SRS test source calibration: measurement bandwidth (comment r03-9)

P802.3cd ad hoc, 10th July 2018

Jonathan King, Finisar

SRS test source calibration measurement bandwidth in D3.2

What does the D3.3 bandwidth description look like ?

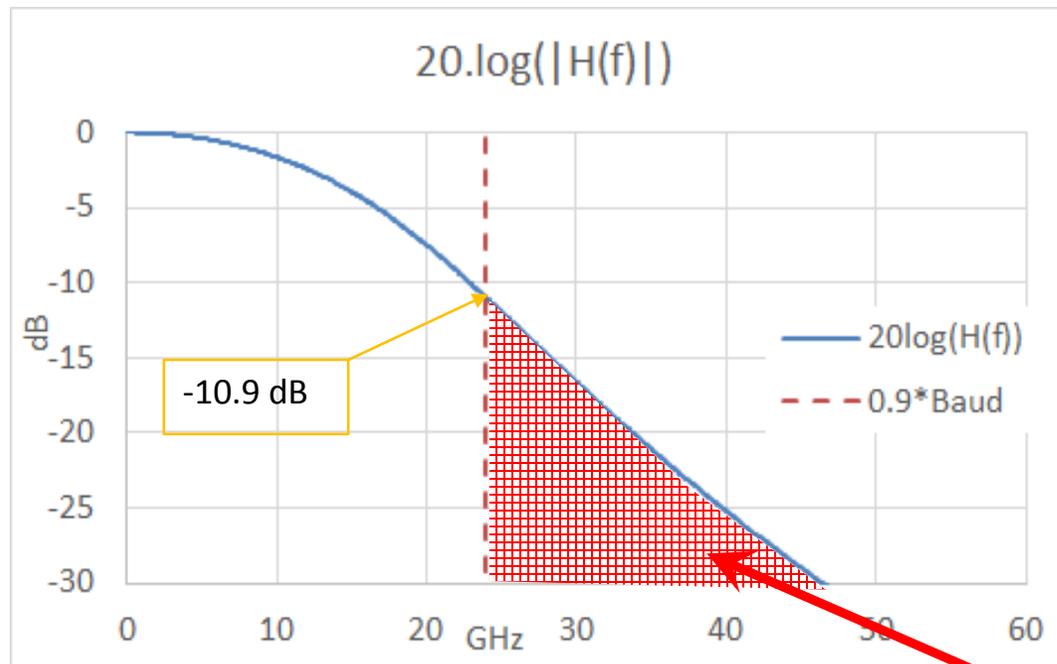
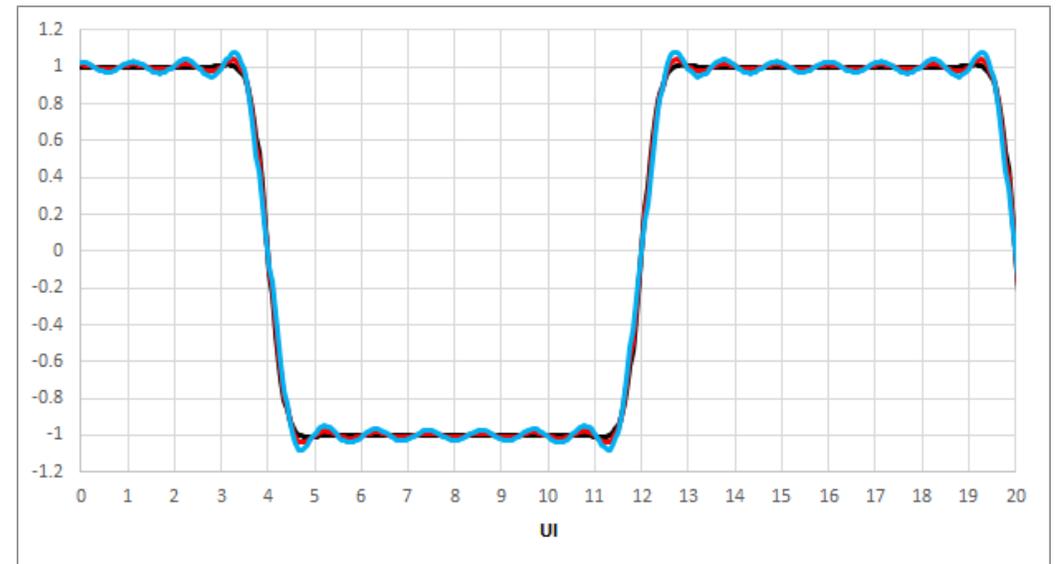
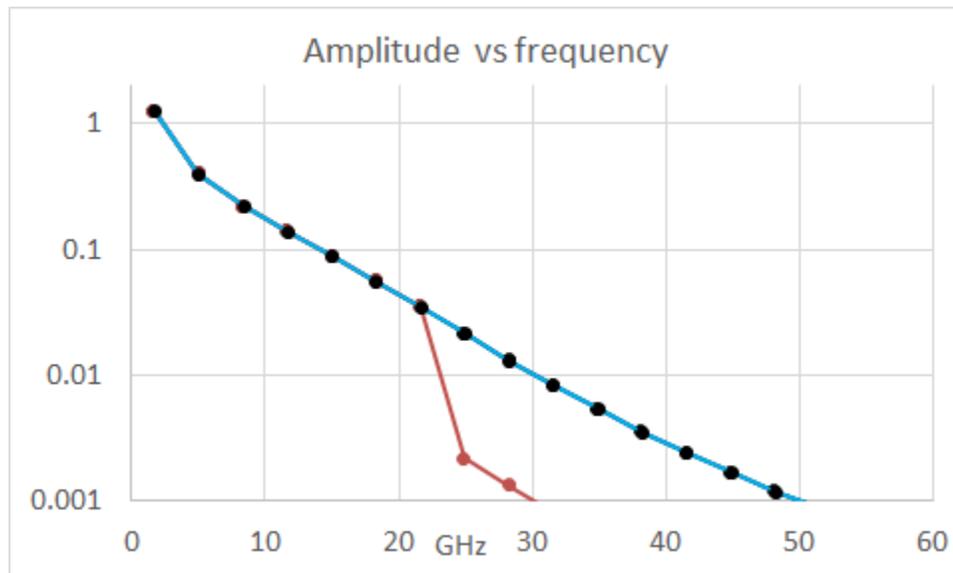
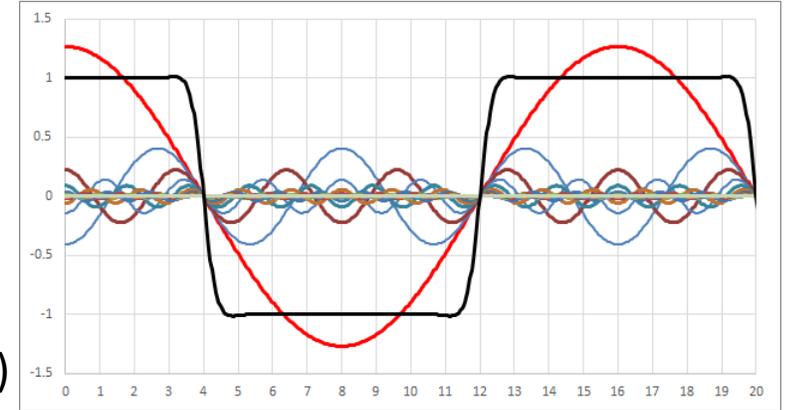
- Removes the need to meet a fourth-order Bessel-Thompson response for frequencies above $0.9 \times$ Baud
 - Allows any phase response provided it doesn't exceed the magnitude response of a BT4 up to $0.9 \times$ Baud
 - No constraints at all beyond $1.5 \times$ Baud
 - This seemingly precise definition makes it even less likely that a casual reader will pay attention to warnings about jitter and noise given, for example, in 139.7.9.3.

-10.9 dB (electrical) = 28% voltage

For a BT4 filtered white noise source, area represents 2.8% power

D3.3 SRS bandwidth applied to transition time measurement -1

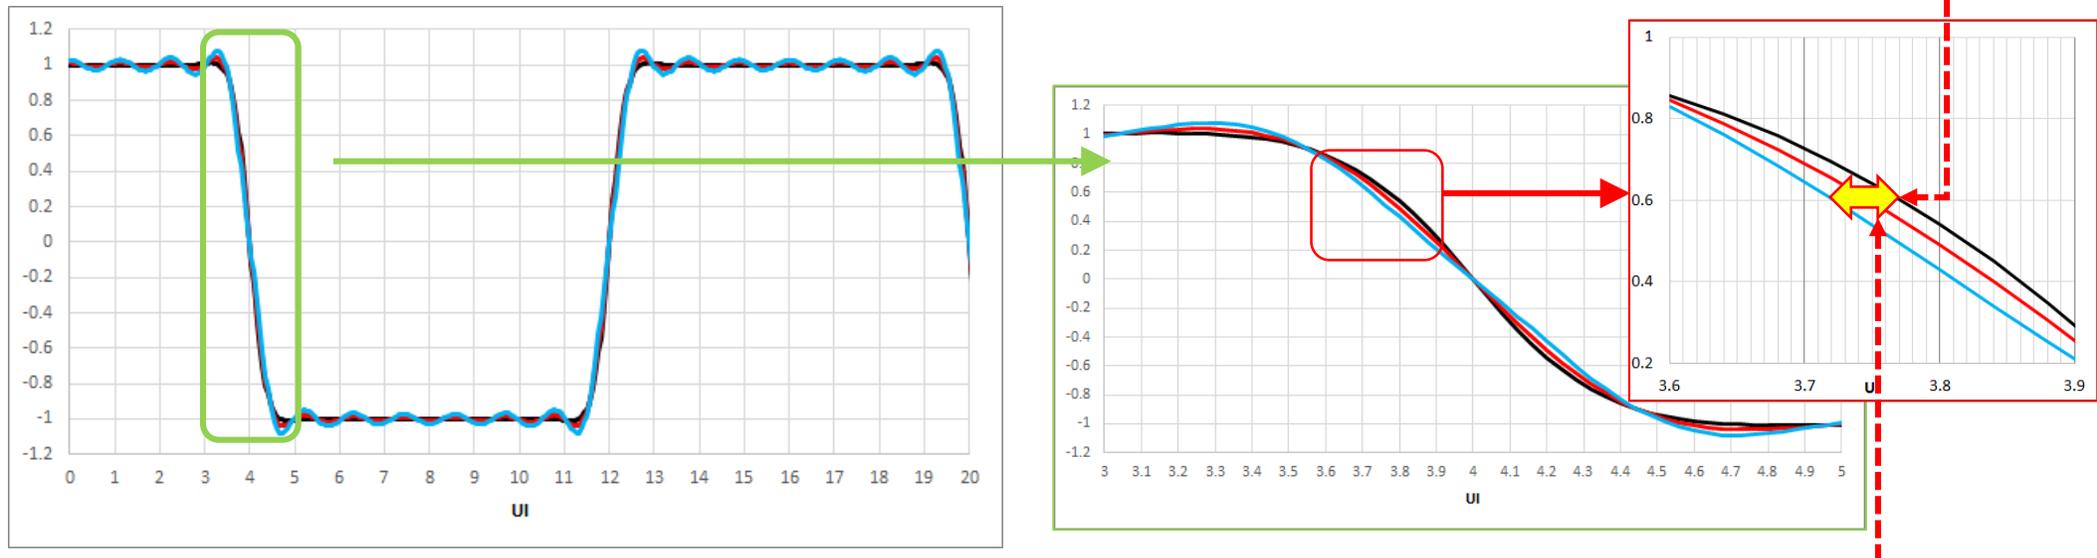
- Square wave test pattern, 3 conditions:
 - BT4 response per D3.2, one answer
 - BT4 with components attenuated by factor of 10 at 0.9xBaud,
 - BT4 with π phase shift at 24GHz

Range of responses allowed by D3.3

- ~20% variation in transition time measurement

Transition time error vs HF spec -1

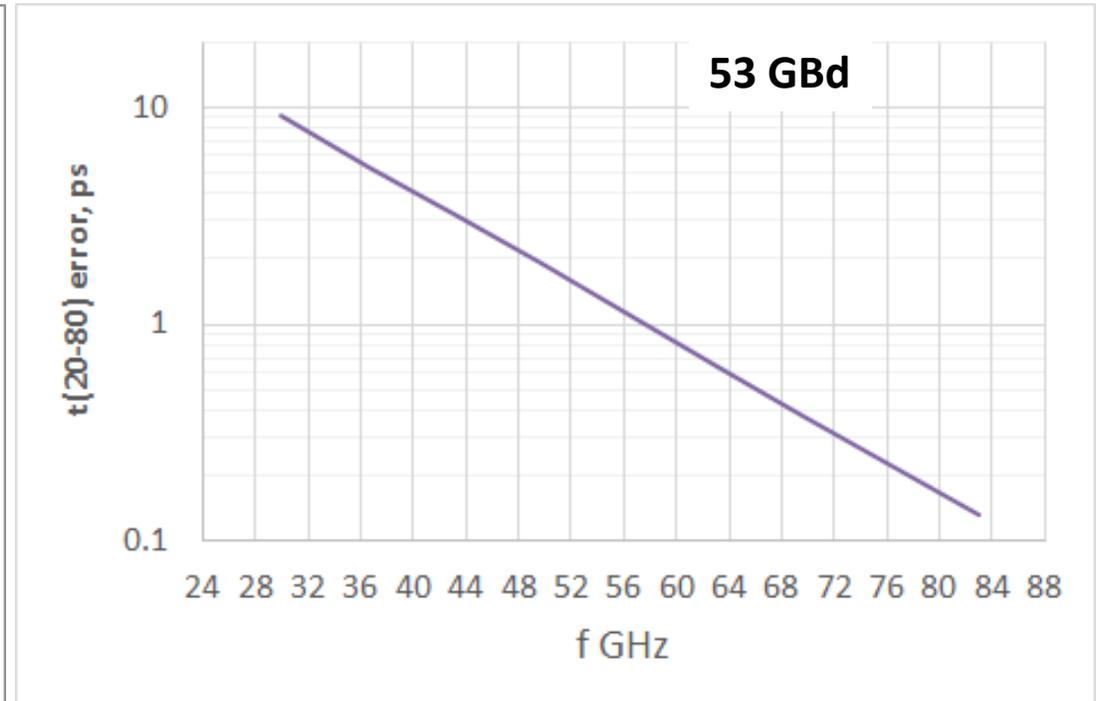
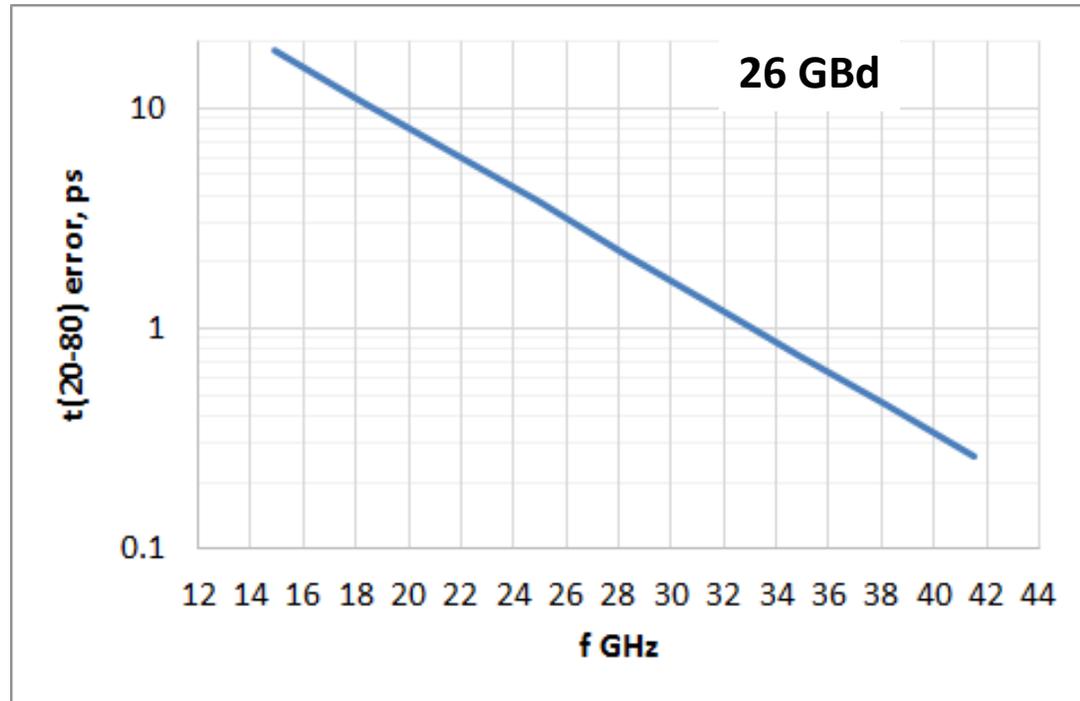
- Transition time variation (ps) vs frequency (GHz) up to which BT4 response is required

Transition time error vs HF spec -2

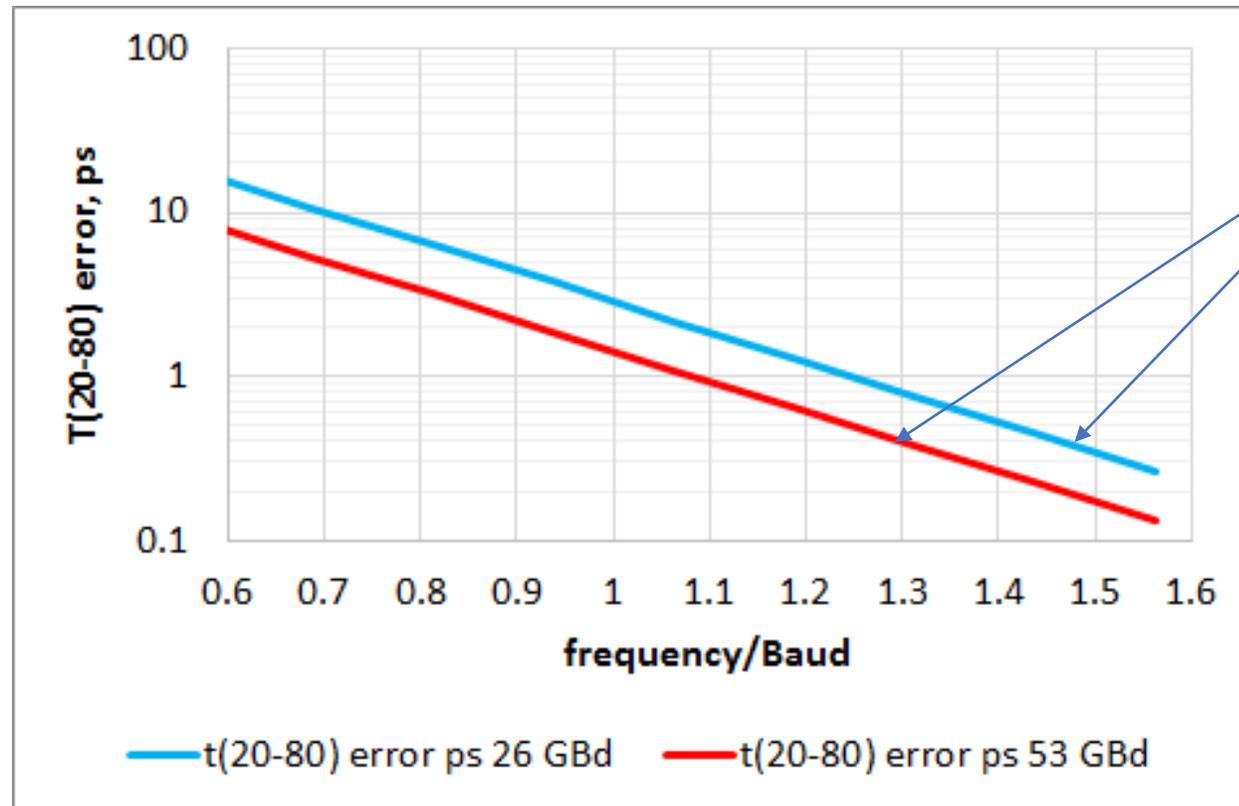
- Transition time variation (ps) vs frequency/Baud up to which a BT4 response is required

~0.4 ps
max transition
time error

Example of transition time error for a slow transmitter

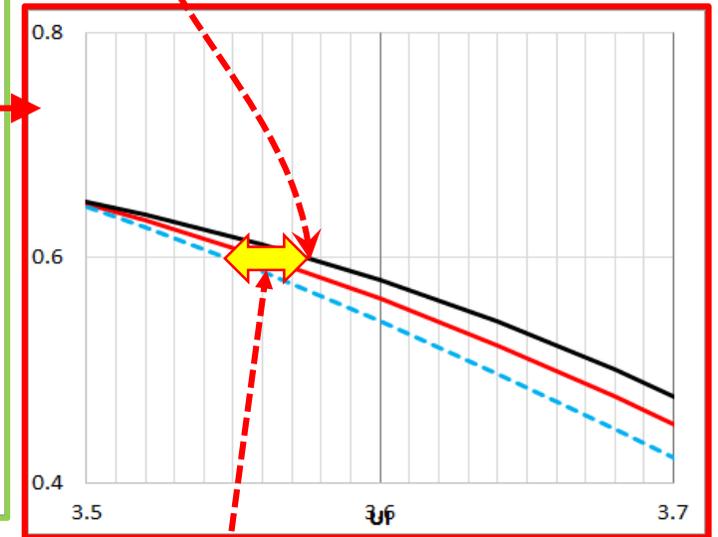
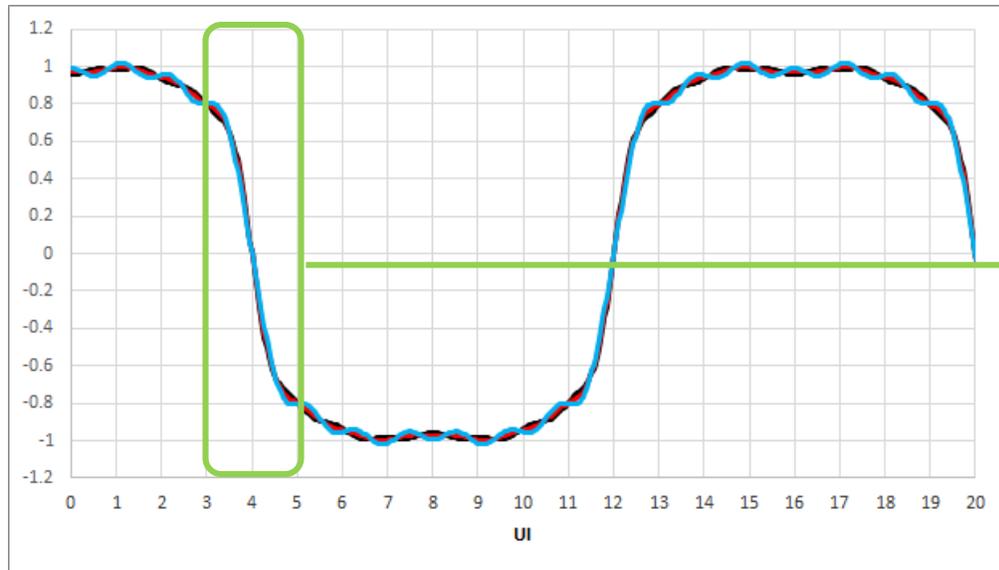
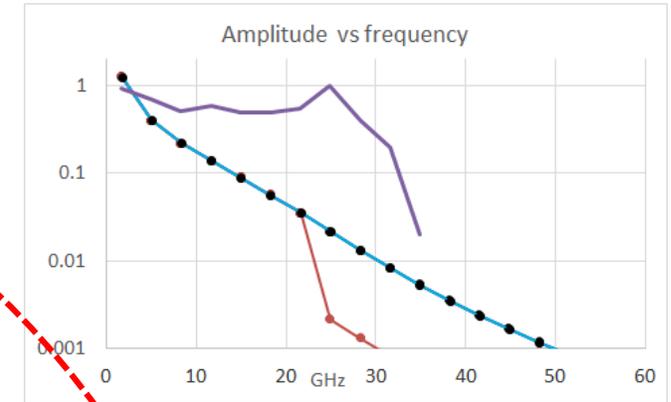
- Slow Tx ($T_{20-80} = 0.85 \text{ UI}$), square wave test pattern, with:
 - BT4 response per D3.2, one answer, **PASS**
 - BT4 with components attenuated by 10 at 0.9xBaud, **MARGINAL**
 - BT4 with π phase shift at 24GHz, **FAIL**

- >7% variation in transition time measurement for this example

- Change the SRS test source measurement bandwidth definition in 138.8.10 to:
“This frequency response should be followed to at least 1.5×26.5625 GHz and at frequencies above 1.5×26.5625 GHz the response should not exceed -25 dB.”

- Change the SRS test source measurement bandwidth definition in 139.7.10.2 to:
“The filter response of the combination of the O/E and the oscilloscope used for the SECQ measurement should be a fourth-order Bessel-Thomson filter response with a bandwidth of approximately 13.28125 GHz to at least 1.5×26.5625 GHz and at frequencies above 1.5×26.5625 GHz the response should not exceed -25 dB.”

- Change the SRS test source measurement bandwidth definition in 140.7.10 to:
“The filter response of the combination of the O/E and the oscilloscope used for the SECQ measurement should be a fourth-order Bessel-Thomson filter response with a bandwidth of approximately 26.5625 GHz to at least 1.3×53.125 GHz and at frequencies above 1.3×53.125 GHz the response should not exceed -20 dB.”

Note: Limits transition time variation to <0.4 ps and TDECQ variation to less than ~0.1 dB.
